RE: Reconsideration for case #C15-2010-0097 at 2206 E 14th St

CITY OF AUSTIN
Board of Adjustment/Sign Review Board
Decision Sheet

CASE NUMBER: C15-2010-0097

Re: Case Number C15-2010-0097, 2206 E. 14th St.

North Elevation- Permitting set 12 Feb 2008- two story garage

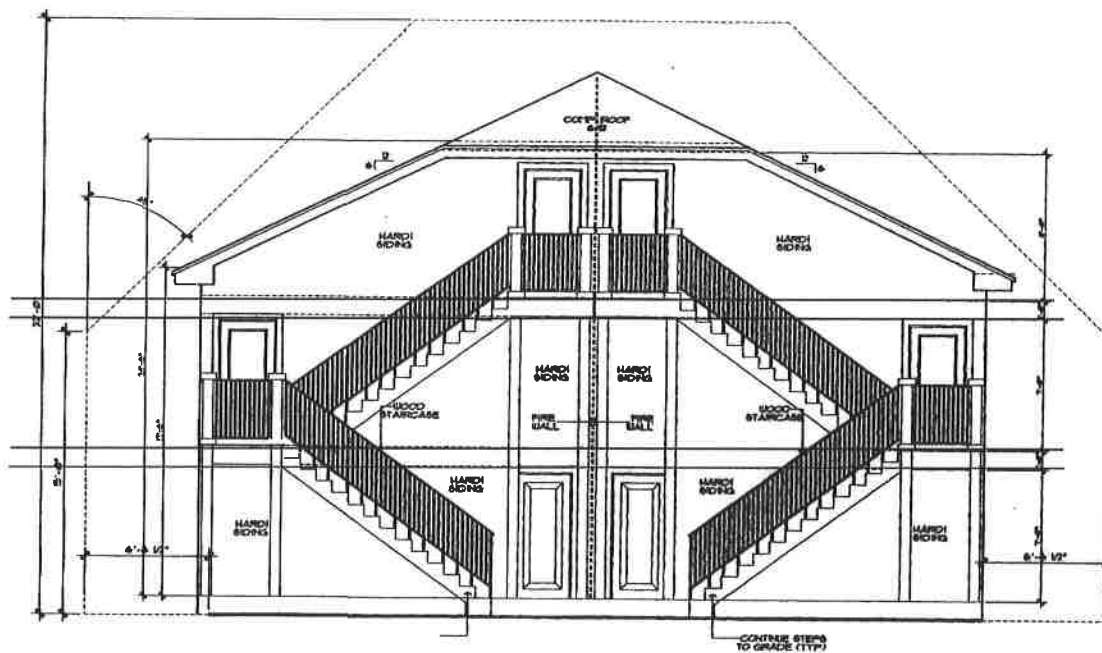
We object for five reasons. First, the garage structure in question was not built in accordance with the plans submitted to the COA. In the permit plans, the garage is shown as a two-story structure, whereas in actuality the building was constructed with three stories. This deviation from the permitting set suggests to the Chestnut NPCT that the developer willfully misled the COA.

Third, the developer submitted sealed as-built drawings to the COA that were, by the developer's own admission, not in accordance with the built structure. Again, the deviation is a sign of the willful misleading of the COA.
